Memorandum

RE: **P.Z. 19-2021 2030 Clarkson Road (Srilakshmi Properties, LLC):** A request for a zoning map amendment from the “NU” Non-Urban District to “R5” Residential District for 2.84 acres located on the north side of Old Clarkson Road and southeast side of Clarkson Road (20T640517).

Planning Commission Staff Report

Re: 2030 Clarkson Road – P.Z. 19-2021

TREE STUDY

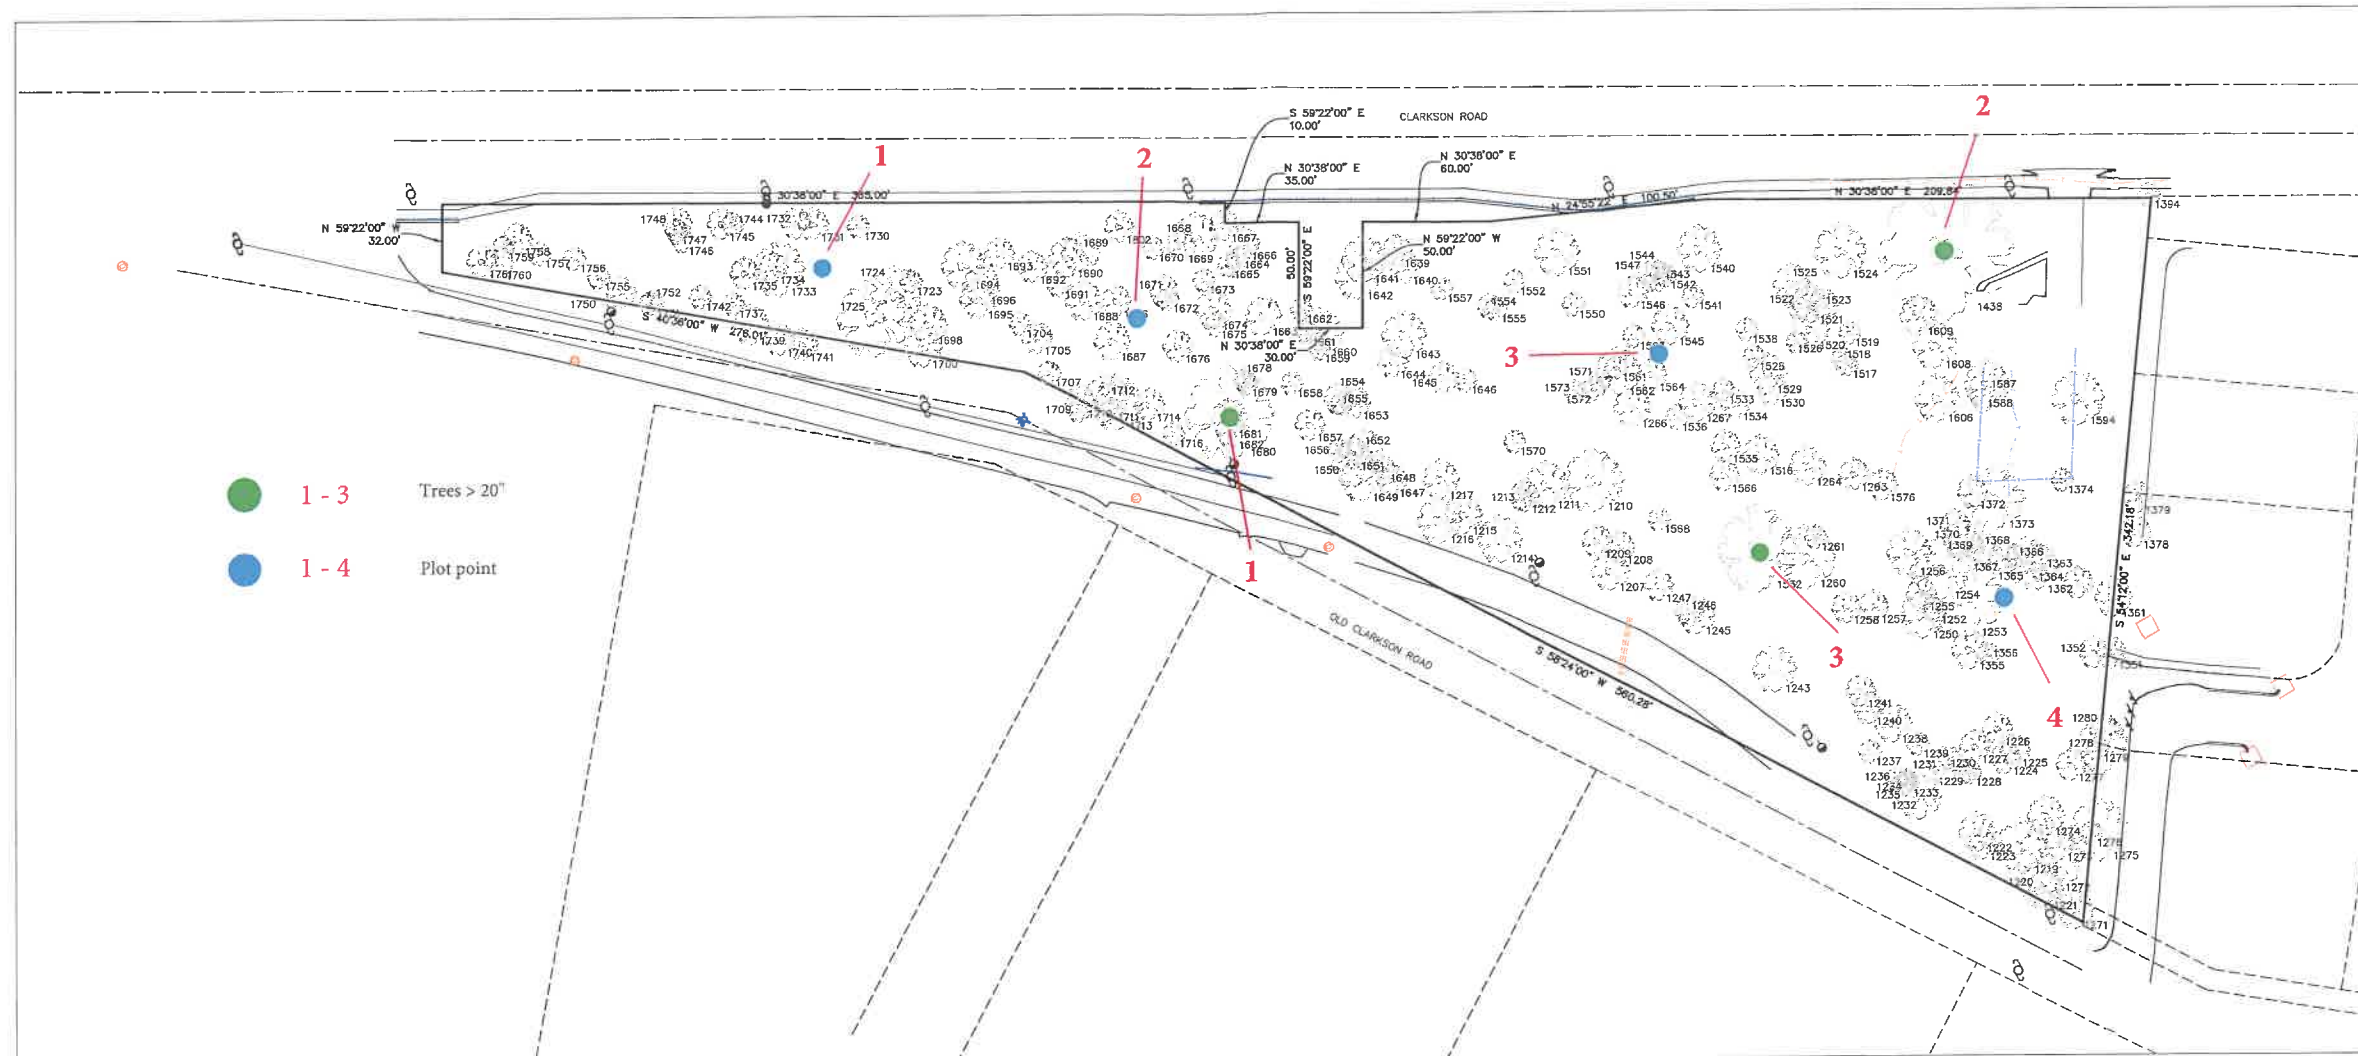
1. As per City of Chesterfield Unified Development Code Section 405.04.020 F point 4 (a) “Tree Stand Delineation shall be signed and sealed by a tree specialist.”
 - Acknowledged and addressed.
2. Provide the location, type, and size of all Monarch Trees as shown on the TSD and the critical root zone for those Monarch Trees within fifty (50) feet of the limit of disturbance. A Monarch Tree is defined in the City’s Unified Development Code and detailed below.
 - Acknowledged and addressed.

3. The total acreage of trees shall be provided on the TSD as this is the quantity utilized to capture the 30% tree preservation requirement in the City's Unified Development Code. Amend accordingly.
 - Acknowledged and addressed.
